**Cardinia Planning Scheme Amendment C262card and
Permit Application T190728
Thom Street, Lang Lang subdivision**

Panel Report

6 December 2022

Permit Application T190728

Figure 4 Lang Lang Framework Plan

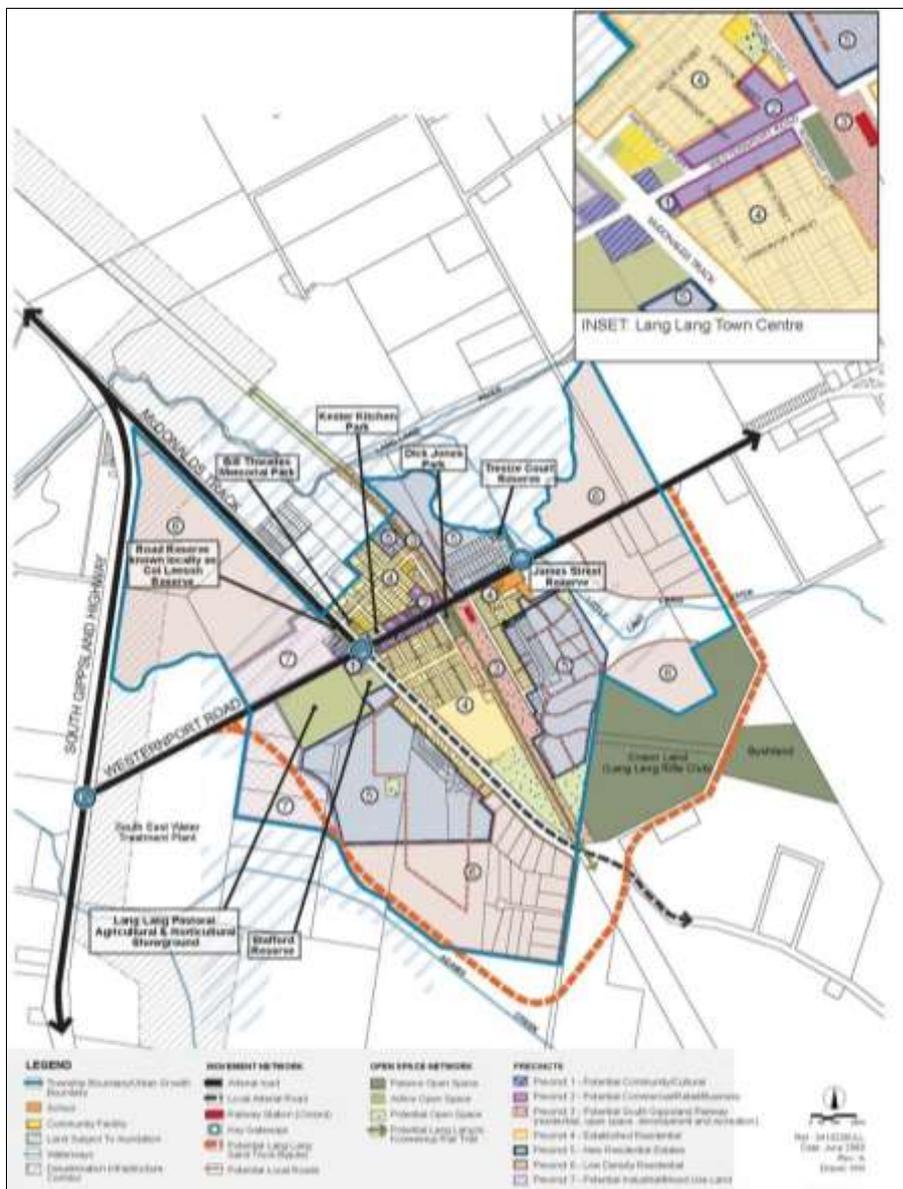
Ensure that any proposed use or development within or around the Lang Lang township is generally consistent with the Lang Lang Township Strategy, July 2009, including the Lang Lang Framework Plan (Figure 1).

Establish local road connections between properties as set out in the Lang Lang Framework Plan (Figure 1).

The Lang Lang Framework Plan supports the construction of a multi-use path along the reserve.

Figure 6 Extract of the Lang Lang Framework Plan showing the rail corridor

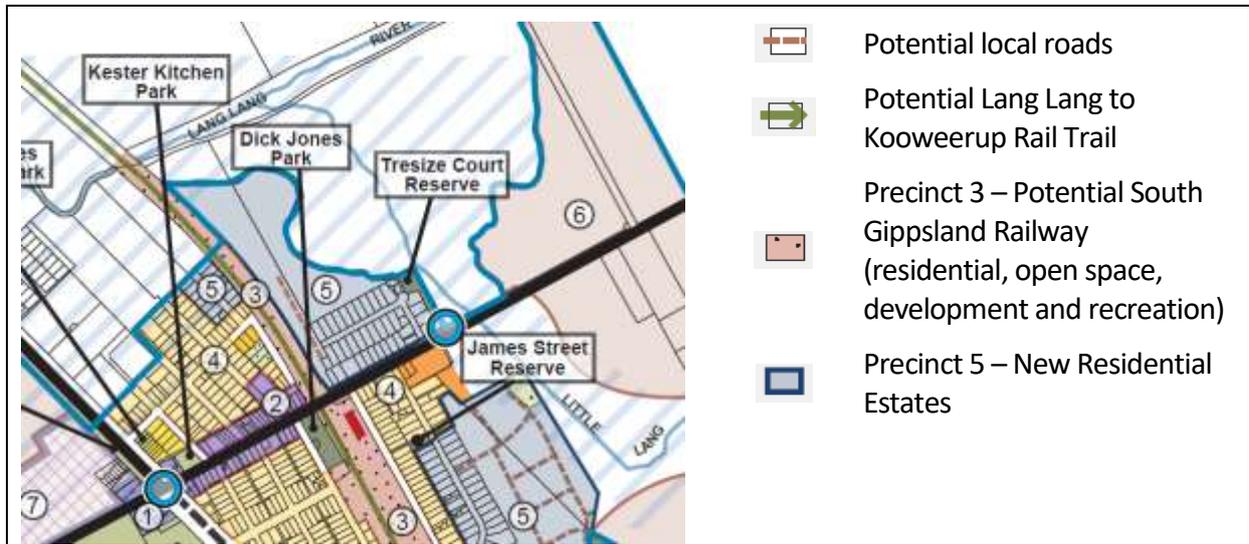
Planning strategies and plans³ show a rail extension to Clyde but there are no strategies extending the rail beyond that, though there are some local campaigns for an extension, notably to Kooweerup which is closer to Melbourne than Lang Lang. The extension to Lang Lang or beyond would be expensive but serve only a relatively small population. The Panel does not consider it likely, but it cannot be ruled out with certainty.

The land is relatively close to the centre of Lang Lang but is poorly connected by the road network and lacks a direct connection to the town centre. Because there is no access across the railway reserve there is an additional journey distance of 500 metres to get to the town centre: 800 metres as proposed against 300 metres if there were a path along the railway reserve. The lack of a connection would add about 1 kilometre to a round trip to the shops. The Panel considers this should have been more clearly identified in background information.

- 1. The subdivision layout be revised to put the road on the west side with links reserved through to developable land to the east and appropriate defensible space arrangement on the adjoining land.**
